REMEDIATION SYSTEM EVALUATION

**PENTA WOOD PRODUCTS SITE
DANIELS, WISCONSIN**

Report of the Remediation System Evaluation
Site Visit Conducted at the Penta Wood Products Site
October 12, 2005

Final Report
February 14, 2006

Figure 1-2 EXTENT OF PCP GROUNDWATER CONTAMINATION 2004

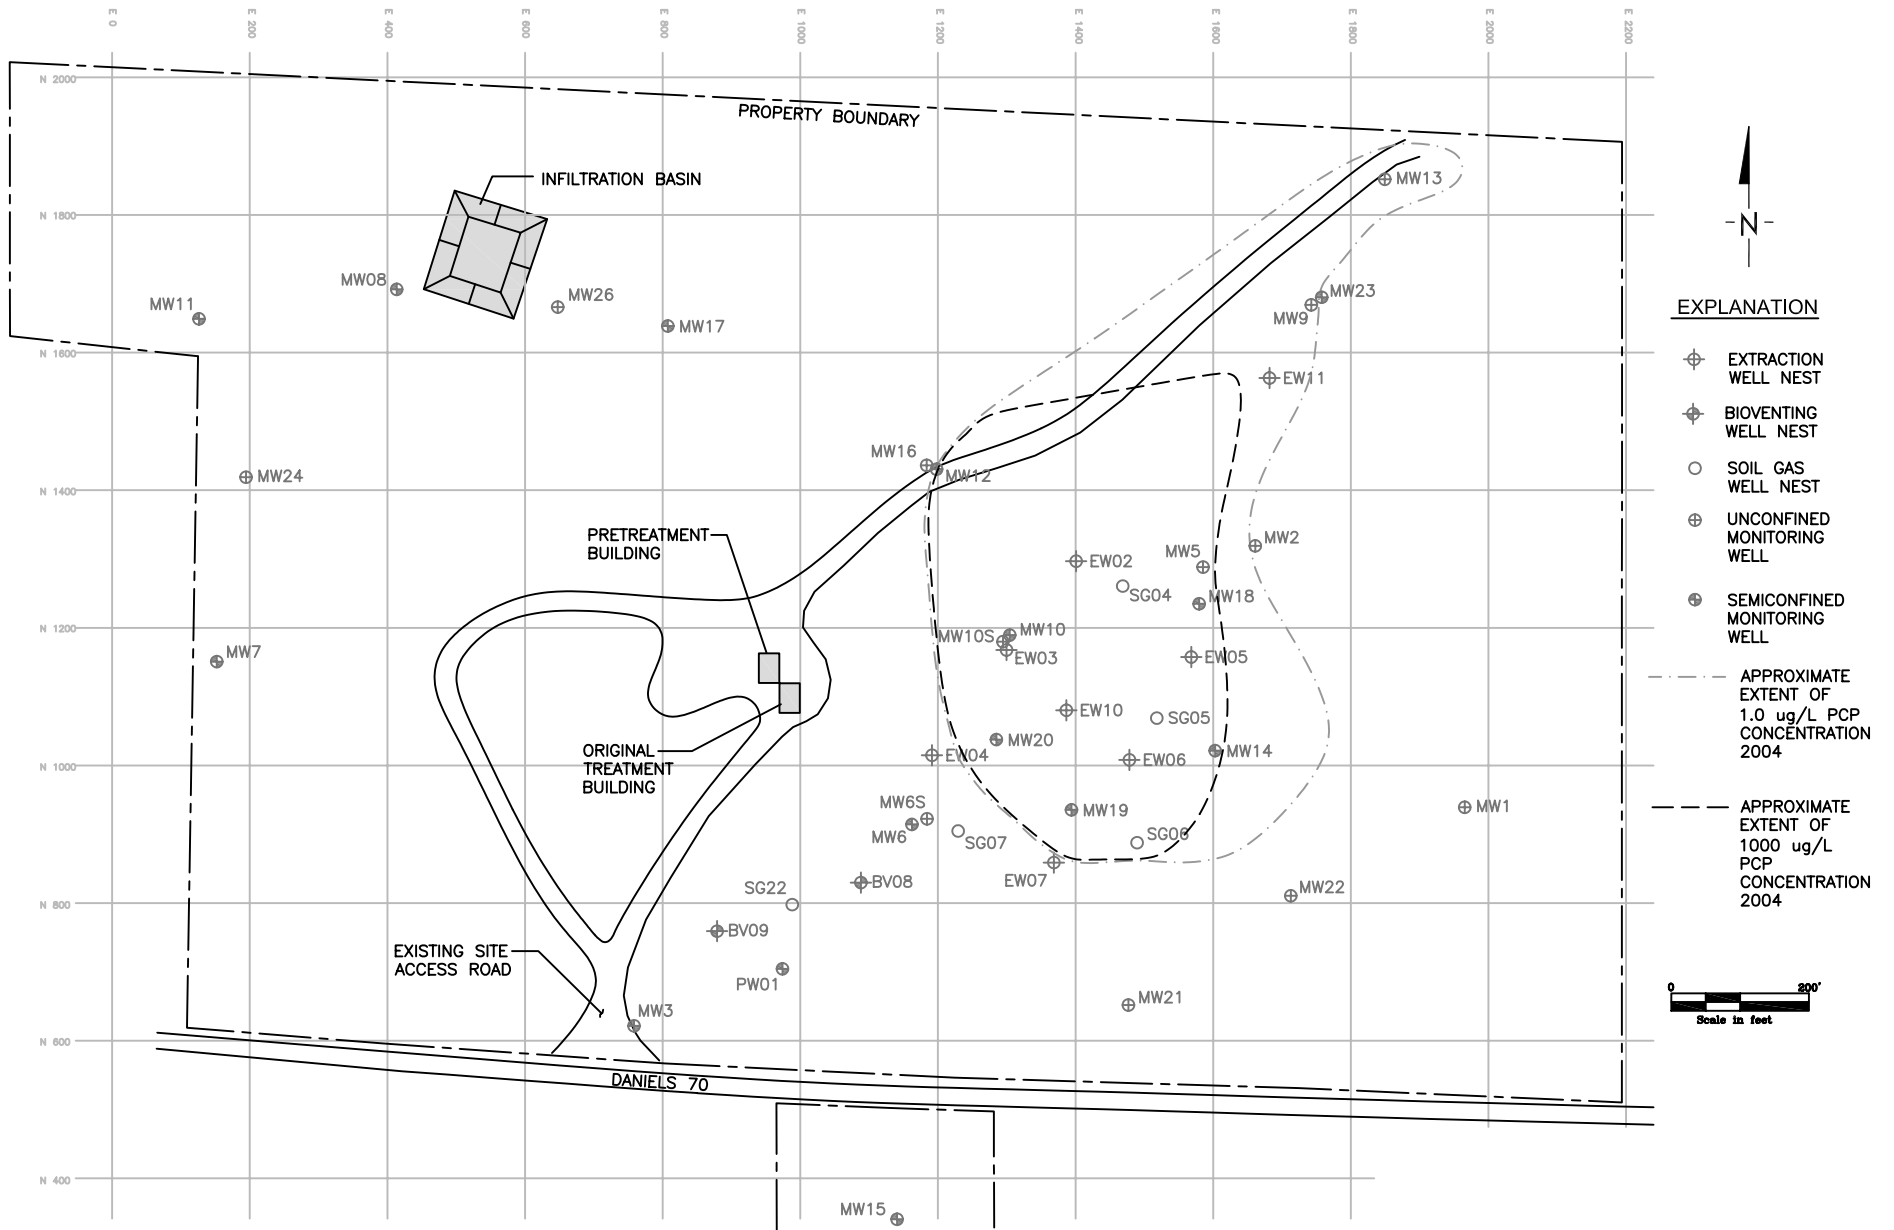
below 1 ug/L. However, there are a few exceptions. Most notable is the detection of PCP at 2.9 ug/L and 4.67 ug/L in MW-13 in 2003 and 2004, respectively. This increase, if statistically significant and not the result of cross contamination from other samples, could indicate that the plume is migrating to the northeast.

The 2003 and 2004 increases in PCP concentrations for MW-13 suggest that the PCP plume might be expanding toward the northeast. Additional years of monitoring data will help confirm if the plume is expanding. The current system is not designed to provide hydraulic containment, so it is possible for the system to operate as intended and for the plume to potentially expand. The migration toward MW-13 is away from residences with potable wells but is toward wetlands and lakes to the northeast of the property. The remedy currently appears to be protective of human health and the environment but future monitoring will need to be evaluated to determine if the remedy will be protective over the long-term.

The potential migration evidenced by increased PCP concentrations in MW-13 suggests the need to continue to closely evaluate the concentration trends in this well to determine if plume migration is occurring. It is recommended that the site team continue to closely follow the sampling data from this and other monitoring wells to evaluate the potential for plume migration. These monitoring wells represent the only source of information that will provide evidence of migration before residential wells or ecological receptors are impacted. If continued increases are observed in MW-13, the site team may want to consider installing a monitoring well approximately 300 feet east of MW-13 (if access is available) to monitor potential migration in this direction. If data suggests that migration is occurring in the direction of the residences, a more thorough capture zone analysis is likely merited to determine if pumping needs to increase to prevent migration and protect these wells.
